PD Modification Application: PRS 24-0279

BOCC Land Use Meeting Date: April 9, 2024

1.0 APPLICATION SUMMARY

Applicant: Tampa Electric Company
 FLU Category: OC-20 (South of Sinclair Hills Rd);
 R-4 (North of Sinclair Hills Rd.)
 Service Area: Urban
 Site Acreage: Approximately 30.54 acres
 Community Plan Area: Lutz
 Overlay: None
 Request: Minor Modification to PD 03-1124

2.4 Proposed Site Plan

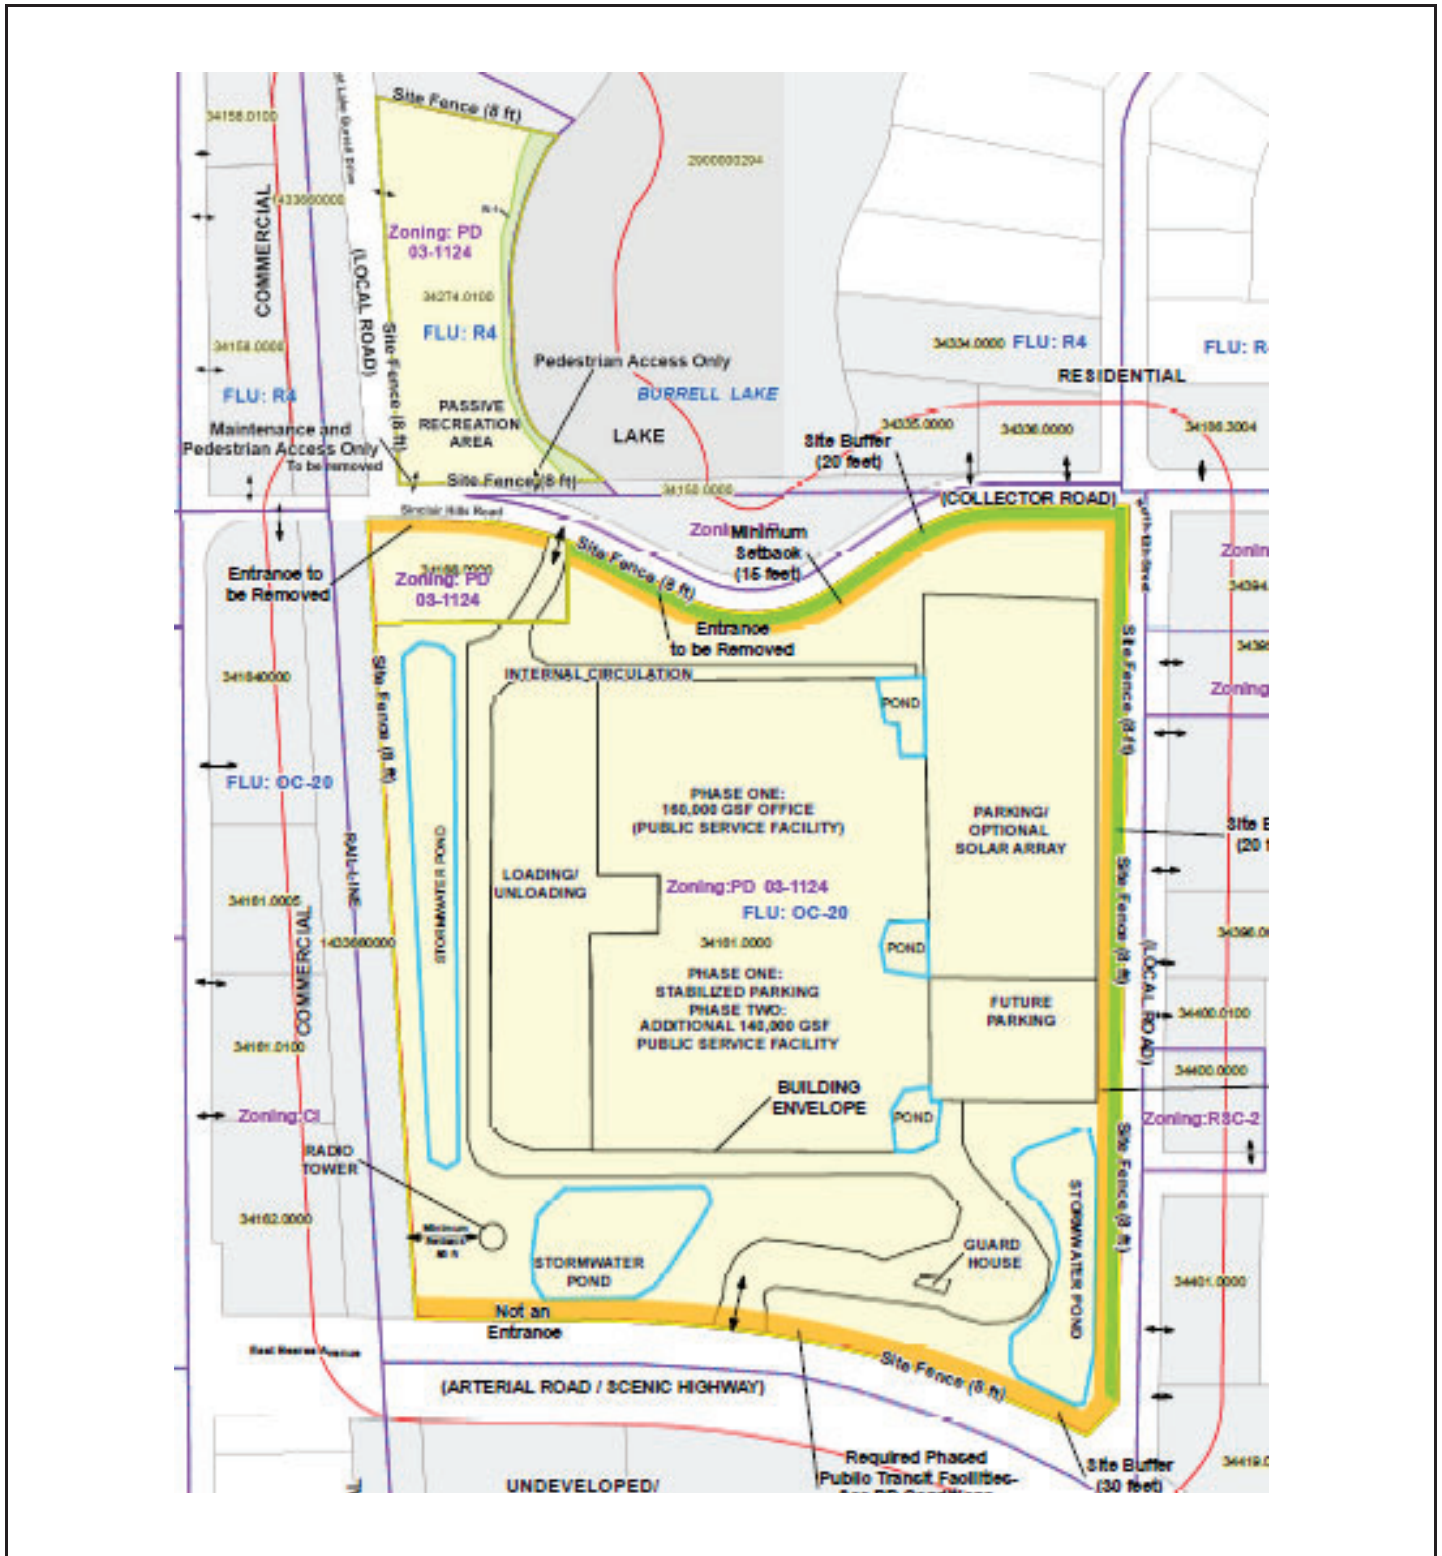
This Minor Modification proposes to allow flexibility to construct the sidewalk along the east side of 12th Street to preserve existing vegetation. If not feasible, the applicant proposes to retain the current option of constructing the sidewalk on the west side of 12th Street. The applicant proposes to add condition 3.1 to allow the developer to relocate the North 12th Street pedestrian sidewalk from the west side of North 12th Street to the east side of North 12th Street, subject to being able to acquire any additional needed right-of-way to relocate the pedestrian sidewalk. The applicant states, the reason for this request to allow flexibility in the placement of the sidewalk is to facilitate the preservation of existing on-site trees and other vegetation within the North 12th Street buffer area. The applicant proposes condition 3.1, reflecting this request.

The applicant proposes to relocate the existing access to the Outdoor Recreational Area from Sinclair Hills Rd. to a location along West Lake Burrell Drive. The new relocated access shall be limited to maintenance vehicles, employees and invited guest parking not to exceed 10 parking spaces. As needed for access to the Outdoor Recreational Area the applicant also proposes modifying traffic conditioning relating to Sinclair Hills Road and West Lake Burrell Drive to add traffic calming including a traffic circle along Sinclair Hills Road. Third, the applicant proposes to redesign and construct a roundabout at the Sinclair Hills Road entrance. Roundabout would include pedestrian crosswalks connect the required 12-foot multi-use path on the south side of Sinclair Hills Road (Condition 15).

Prior to PD site plan certification, the following shall be revised:

- Revise “Passive Recreation Area(s)” to Outdoor Recreation Area(s)”.
- Revise “Pedestrian Access Only” to “Pedestrian Access - Typical”.
- Add following note adjacent to West Lake Burrell Access: “Relocated Vehicular Access”.

FIGURE 1
 SINCLAIR HILLS ROAD
 IMPROVEMENT LIMITS
 225-0089

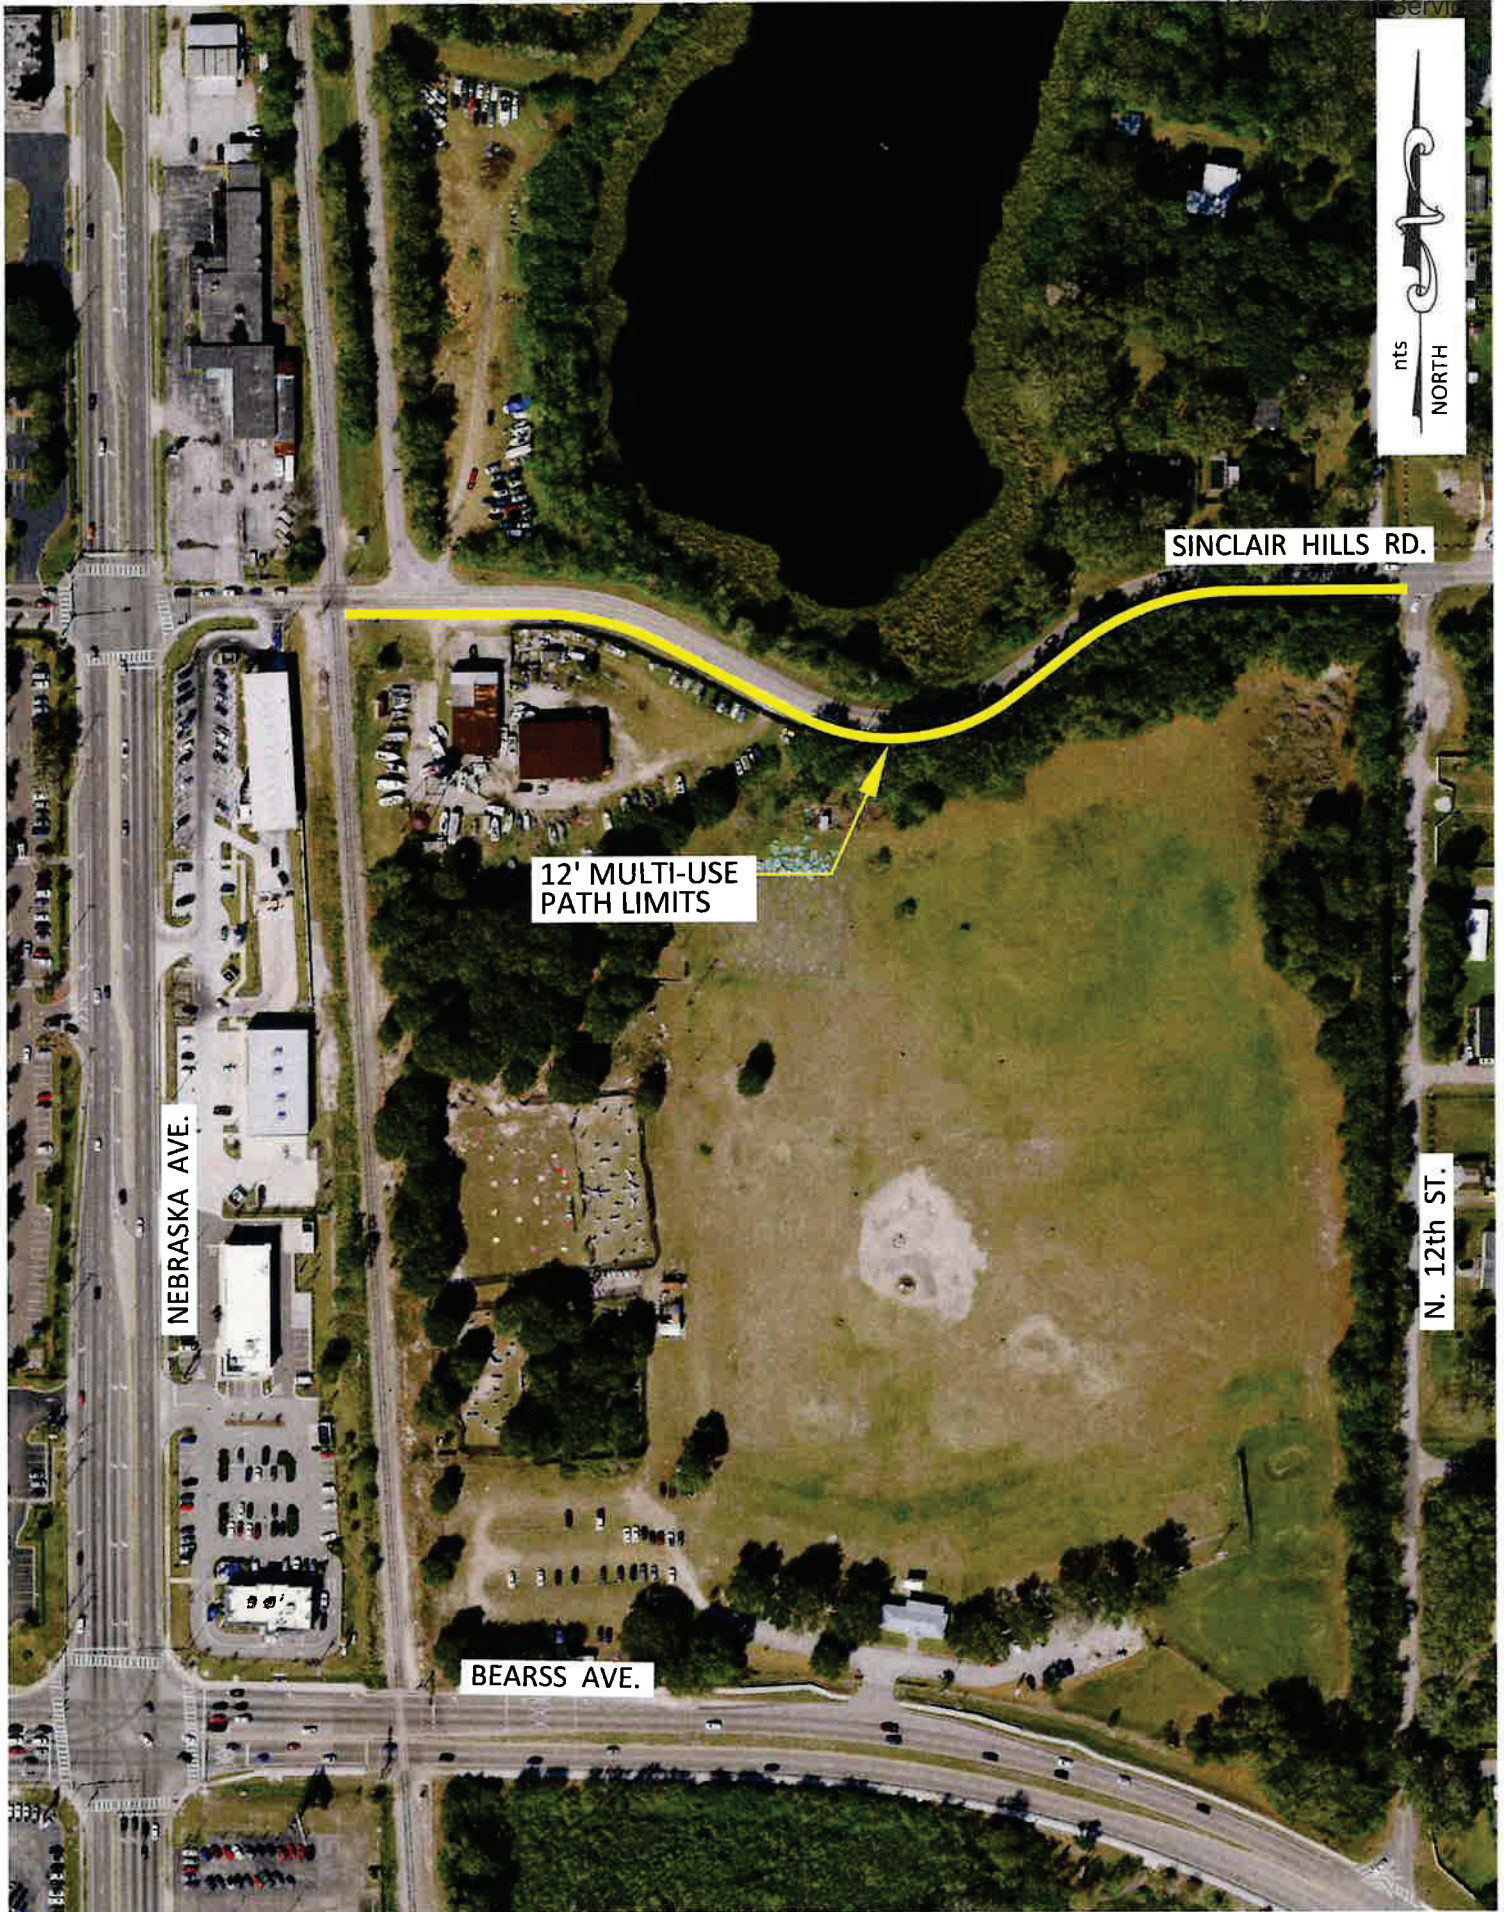
1. There is limited right of way on the north side of Sinclair Hills Road.
2. The developer proposes the following improvements:
 - a. Provide an eastbound right turn lane into the project access
 - b. Provide a 12 foot multi-use path on the south side of Sinclair Hills Road from the railroad tracks to 12th Street.

Figure 1 illustrates the limits of the proposed improvements and Figure 2 illustrates the proposed Typical Section.

The County Engineer has reviewed zoning modification application # PRS 24-0279 and determined the changes to be de minimis. As such, the previous approval shall stand.
